# Record of Decision

# Final Environmental Impact Statement

**U.S. 212 Reconstruction of  
Rockvale to Laurel**

## Final EIS Comments and Responses

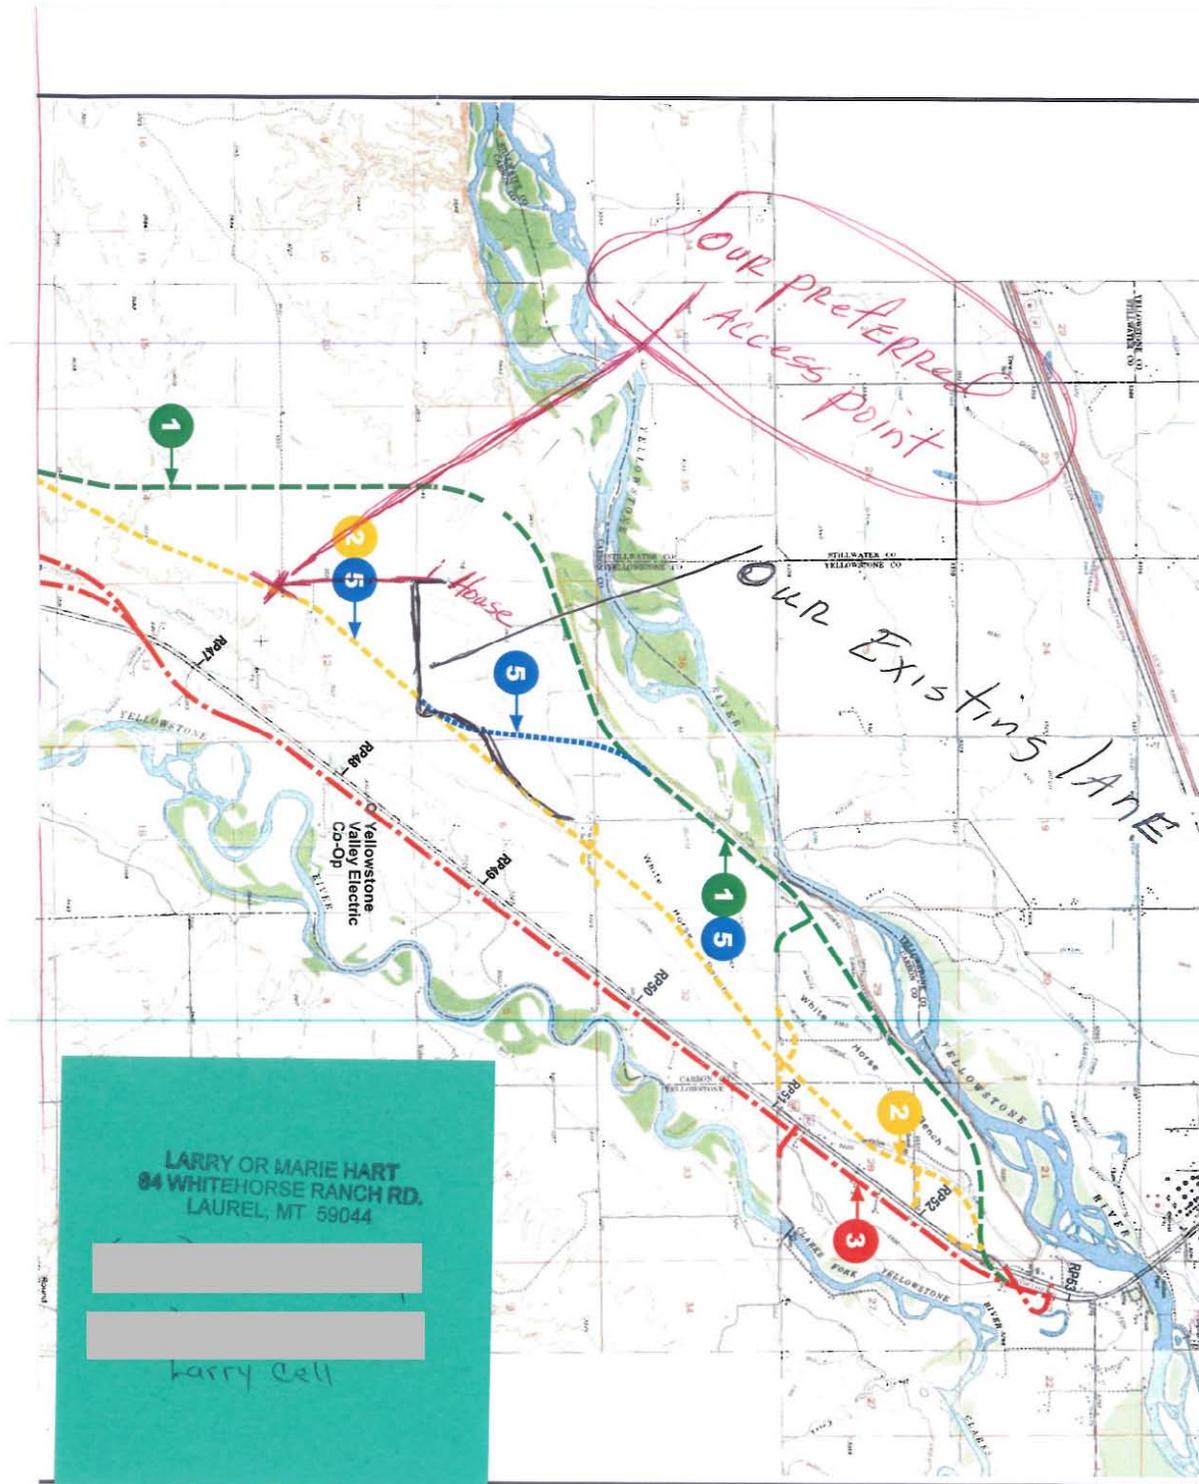
We are the only people living west of the preferred route (5) for the proposed highway. We own land in sections 11, 2, 1, 14, 15, 21 and 22 of 35 23 E. Our lane now goes east on the boundary between sections 1 + 12. (Whitchose Ranch Rd)

We would prefer an access point to the highway where the highway crosses the boundary between sections 11 + 12, which is directly south of our house and yard.

This point is also owned by James Anderson and Robert Hollister, who would also like an access point at this location. (See Enclosed Map)

- 5-1 As stated in the Final EIS, *Section 2.2.3.2, General Access Management*, reasonable access would be maintained to existing parcels adjacent to the highway. Access to businesses and residences would be determined during the design phase of the project. Your recommendation would be considered at that time. When the projects are advertised for construction, potential bidders would be responsible for making their own arrangements for gravel sources. You can make arrangements with the bidders at that time.
